**Addendum No. 1**

RE: Contract # C202581

**Orange-Durham Counties**

SR-1838/SR-2220 FROM US-15/501 IN ORANGE COUNTY TO SR-1113  
IN DURHAM COUNTY

**INDEX OF SHEETS**

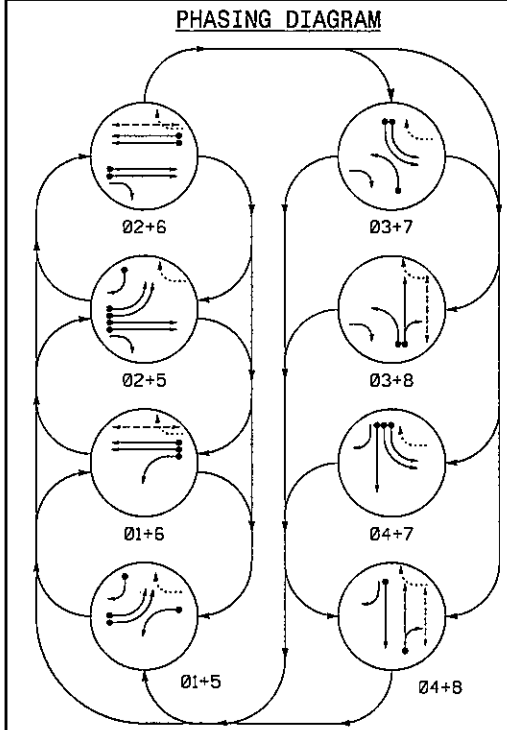
Sheet No.	Revisions
1A	Revised SHEET NUMBER to list SIG-1 thru SIG-4 to reflect the addition of 2 sheets listed below.

Prepared For: US 15-501 (Fordham Boulevard) At SR 1741 (Sage Road) / Scarlett Road

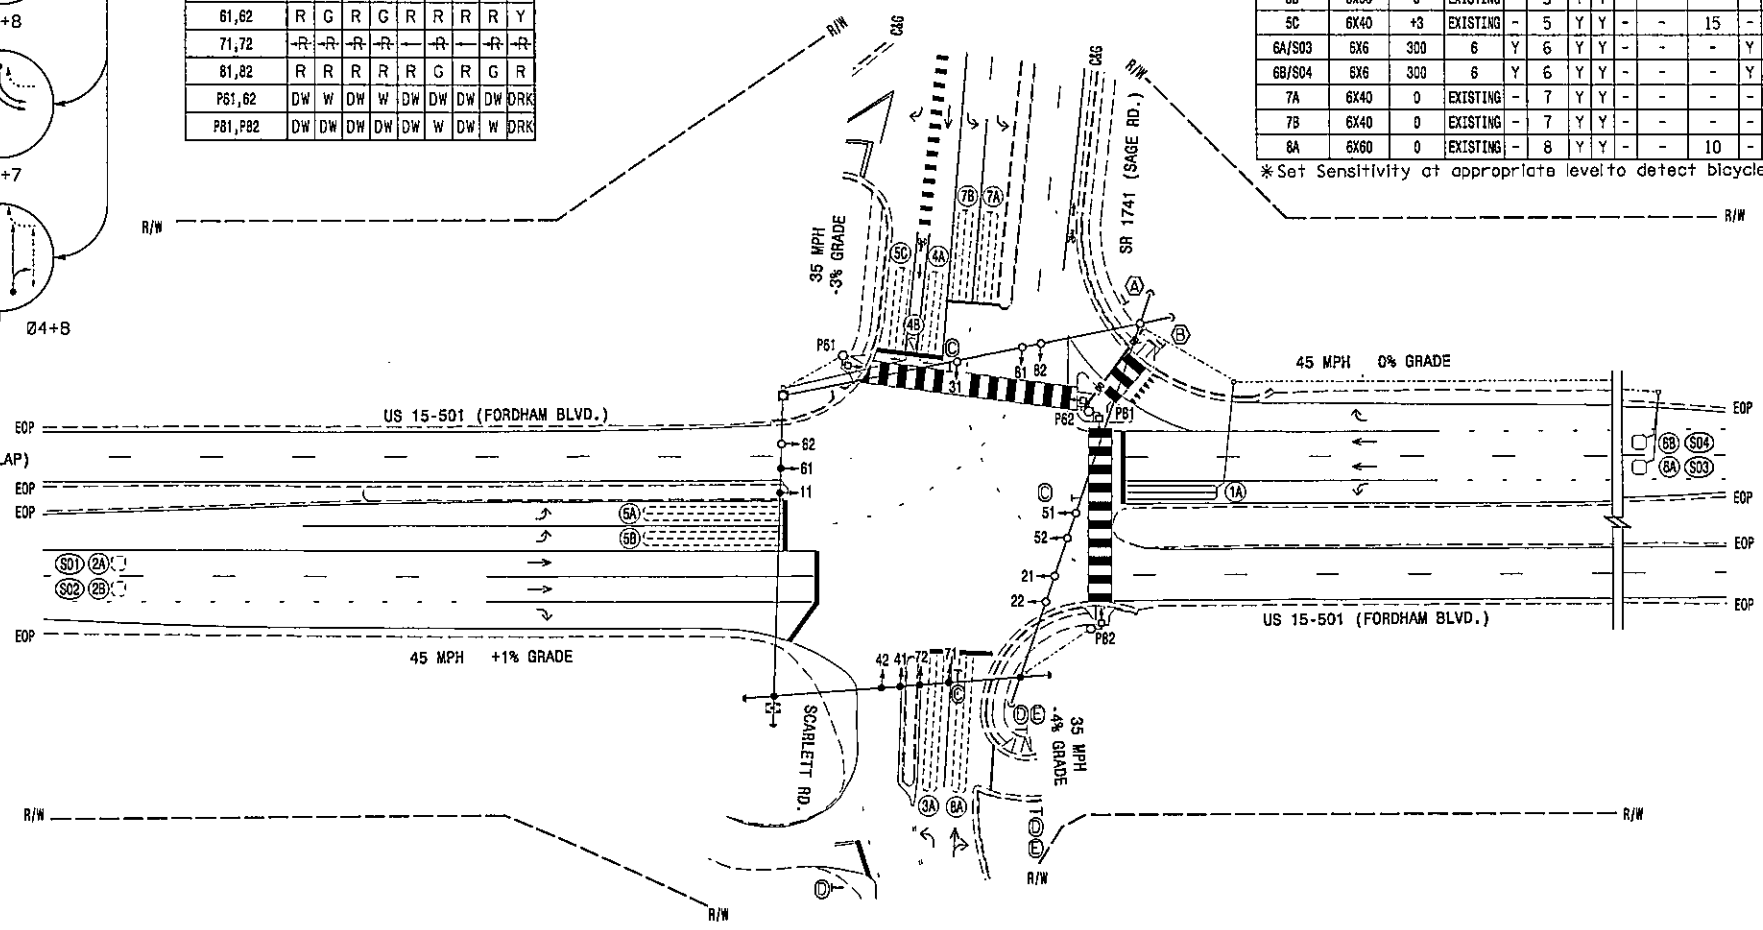
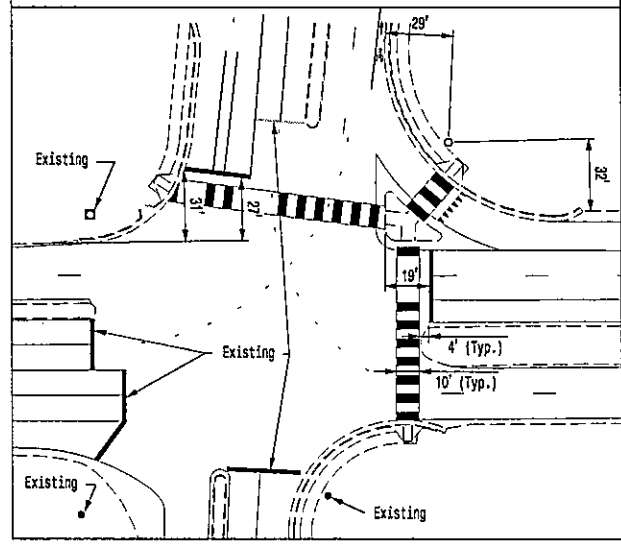
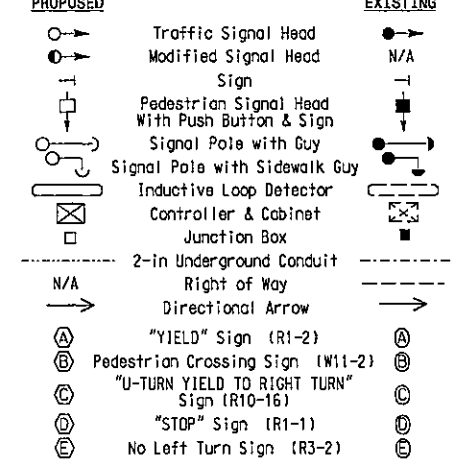
Sheet No.	Revisions
Sheets SIG-1 and SIG-2	Revised to correct labels/notes
New Sheets SIG-3 and SIG-4	Sheets added to provide additional details
